## SB-10056710-3220

2008-2012 Escape

2008-2011 Mariner

### ISSUE

Figure 1 - Article 14-0157

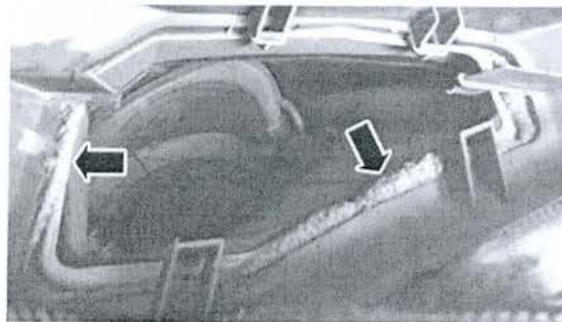
1. Perform the blower motor resistor component check on the vehicle. Refer to Workshop Manual (WSM), Section 412-00.
2. Are the resistance measurements observed within specification?
  - a. Yes - this article does not apply. Refer to WSM, Section 412-00 for normal diagnosis.
  - b. No - proceed to Step 3.
3. Replace the blower motor resistor. Refer to WSM, Section 412-01. Proceed to Step 4.
4. Remove the cowl panel grille. Refer to WSM, Section 501-02.
5. Remove the excess foam seal material from around the inside of the leaf guard rain hat. (Figures 1 and 2)

Figure 3 - Article 14-0157

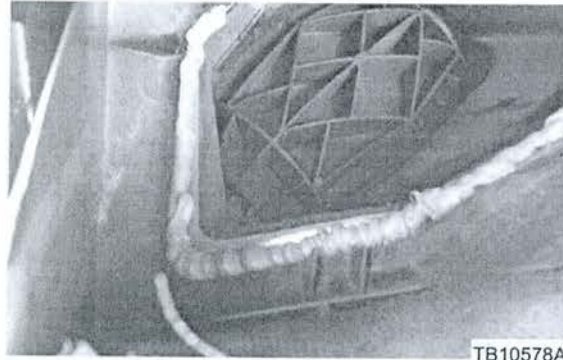
6. Liberally apply Motorcraft Ultra Silicone Sealant to the bottom of the leaf guard where the intake to the heater core and evaporator core housing meet. (Figure 3)

Figure 4 - Article 14-0157

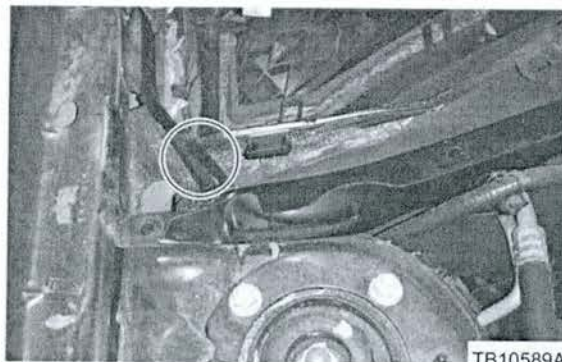
7. Cut away the forward corner of the rain hat to improve drainage. (Figures 4 and 5)

Figure 5 - Article 14-0157

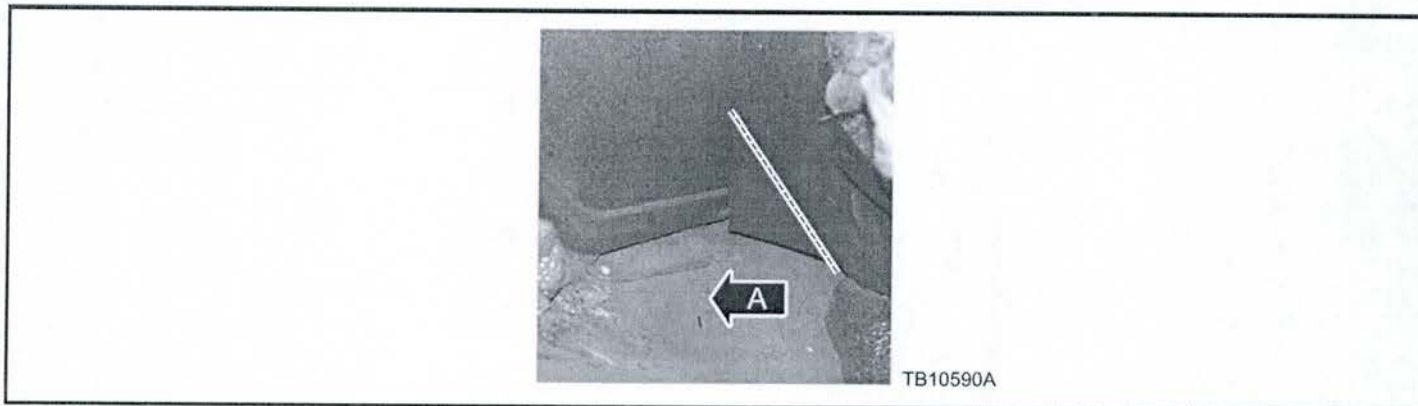
- a. (A) indicates front of vehicle.
- 8. Reinstall cowl panel grille. Refer to WSM, Section 501-02.
- 9. Replace the receiver drier. Refer to WSM, Section 412-01.
